Subject: License No. SUB-1010, Docket No. 040-08027  
Reclamation Plan Acceptance Review, Request for Additional  
Information

**ENCLOSURE 1**  
**Sequoyah Fuels Corporation**  
**Reclamation Plan Acceptance Review**  
**Request for Additional Information**

**SFC Responses to Request for Additional Information**  
**August 29, 2003**

**Revisions to the Reclamation Plan**  
**August 29, 2003**

PREPARED BY: SFC	Filename: SFC0090B
Reviewed by: CH	
Date: 08/26/2003	Figure No.3-2

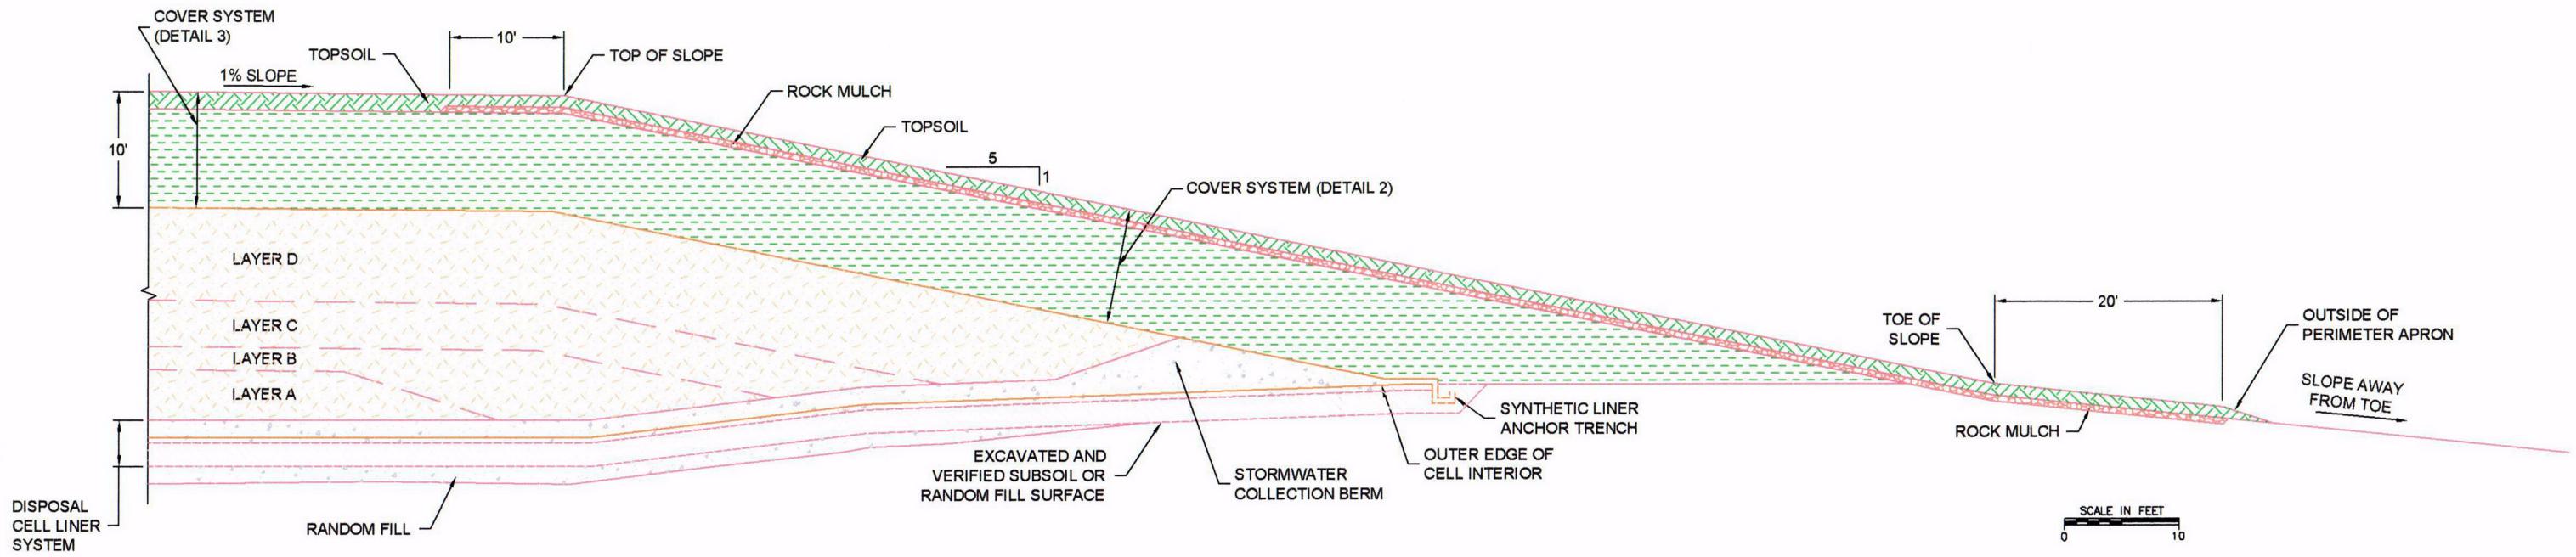
**GW1.** Liner configuration: According to figure 3-2, the liner will only partially underlay the tailings and will not have angled sides to the impoundment. This is not adequate from a groundwater protection perspective. In addition, the application has statements such as "if the clay liner is used." In order to review the design, staff must know what the liner material will be.

Per 10 CFR Part 40, Appendix A, Criterion 5A(2) the liner must be "installed to cover all surrounding earth likely to be in contact with the wastes or leachate." Per Criterion 5A(1) the liner must be "designed, constructed, and installed to prevent any migration of wastes out of the impoundment to the adjacent subsurface soil, groundwater, or surface water at any time during the active life (including the closure period) of the impoundment."

**The original plan consisted of either a compacted clay or synthetic liner beneath Layer A materials, comprising the materials (primarily sludges) with the highest radionuclide concentrations and the most likely to be saturated. A liner system beneath the remaining materials to be disposed was not planned, since these materials are unsaturated and of similar radionuclide concentration as the remaining subsoils.**

**Since the original plan was proposed, ongoing testing by SFC has clarified the dewatering and treatment strategy for the sludges. In order to provide more flexibility in disposal cell operation and water management, SFC has modified the overall containment concept for the disposal cell. This concept incorporates a multilayered liner system covering the entire disposal cell base and a multilayered cover system over the disposed materials. The liner system and cover system are described below.**

**The liner system will include (from bottom to top): (1) compacted random fill (of variable thickness) above the excavated soil surface to achieve desired slopes, (2) a 24-inch thick layer of compacted clay (from on-site sources), (3) a 6-inch thick layer of sand (from off-site sources) as a bedding layer, (4) a synthetic liner, (5) an 18-inch thick layer of sand (from off-site sources) as a protective layer and**

**drainage layer above the synthetic liner. The two sand layers will include a grid of slotted pipe sloped to drain to two external sumps at the southwest corner of the disposal cell. The sumps will serve as monitoring locations for leachate collection (above the synthetic liner) and leak detection (beneath the synthetic liner).**

**The cover system will include (from bottom to top): (1) a compacted and smoothed disposed material surface to provide a bedding layer, (2) a synthetic liner, (3) a 1.5-foot thick layer of cover soils or sand (from on-site or off-site sources) as a protective layer and drainage layer above the synthetic liner, (4) a 7-foot thick layer of cover soils (from on-site sources), and a 1.5-foot thick layer of topsoil and erosion protection material. The upper 1.5-foot thick layer will consist of entirely topsoil (from on-site sources) on the top surface of the disposal cell, and a 1.0-foot thick layer of topsoil above a 0.5-foot thick layer of rock mulch (from off-site sources) on the side slopes of the disposal cell.**

**The synthetic liner to be used in the disposal cell liner system and cover system will most likely be a 60-mil thickness high-density polyethylene that is installed, seamed, and tested according to current liner construction practices. The two synthetic liners will be anchored together along the perimeter of the disposal cell to form a complete geomembrane system around the disposed materials. Long-term containment will be provided by the cover soils and clay liner.**
